# UNITED STATES PATENT AND TRADEMARK OFFICE

| APPLICATION NO. | FILING DATE | FIRST NAMED INVENTOR | ATTORNEY DOCKET NO. | CONFIRMATION NO. |
|-----------------|-------------|----------------------|---------------------|------------------|
| 09/681,403      | 03/29/2001  | Tore Fosse           | VCC0082-US          | 3278             |

# Office Action Summary

FIG. 1

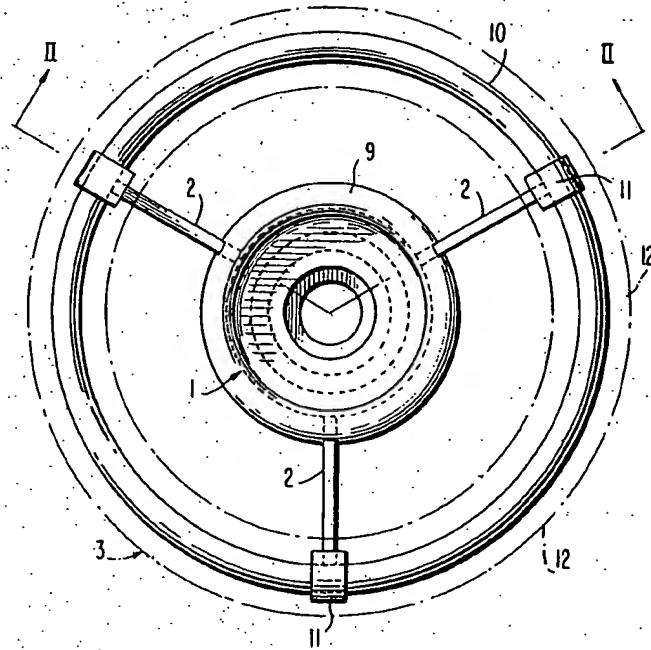
Claims 21, 22, and 27 – 42 are rejected under 35 U.S.C. 103(a) as being unpatentable over Barenyi (US 3,800,604) and further in view of Fohl (EP 0691245). Barenyi discloses a hub (see bottom of 7 in Fig. 2) for fixing to a steering column, a substantially conical bowl-shaped element (see Fig. 2) with a plurality of spokes (2 in Fig. 1), the spokes connected by a reinforcing element (9 in Fig. 1) and further connecting the bowl-shaped element to a steering wheel rim (10 in Fig. 2), the bowl-shaped element further comprising an upper shell part (4 in Fig. 2) and lower shell part (7 in Fig. 2), the upper shell part having larger outer dimensions than the lower shell part and the upper and lower shell parts are connected by a ledge extending substantially radially outwardly from the lower shell part to the upper shell part (see attachment). However, Barenyi does not disclose an airbag or casing with a wall section of the bowl-shaped element at least partly forming part of the means for inflating the airbag. Fohl discloses a vehicle steering wheel including a lower portion (40 in fig. 3) with an integral hub shaped to receive an airbag (24 in Fig. 1), with a wall section of the lower portion of the hub at least partly forming a part of the means for inflating the airbag, in order to provide ease in inserting an airbag into a vehicle steering wheel. Therefore it would have been obvious to one having ordinary skill in the art at the time the invention was made to modify Barenyi by adding an airbag and lower portion with a wall section that at least partly forms a part of the means for inflating the airbag in order to provide an easier way to insert an airbag into a steering wheel assembly, as taught by Fohl. Regarding the hub, bowl shaped element, and spokes being integrally formed, it has been held

Applicant's arguments filed September 23 have been fully considered but they are not persuasive. Regarding Applicant’s argument that Barenyi does not disclose a substantially conical configuration, the examiner disagrees. The article in question is required to be a “bowl-shaped element having a substantially conical configuration”, and the examiner maintains that 4

and 7 in Barenyi have a ‘substantially’ conical configuration – it starts small and gets larger, like the shape of a cone. Also, applicant argues that the ledge structure pointed to in Fig. 2 of Barenyi is not a “radially extending portion of an integral wall that forms both the hub 1 and deformation pot 7”. The examiner disagrees, and maintains that the ledge structure pointed to in Fig. 2 of Barenyi is a “ledge extending substantially radially outwardly from the lower part to the upper part” as claimed in the independent claims.
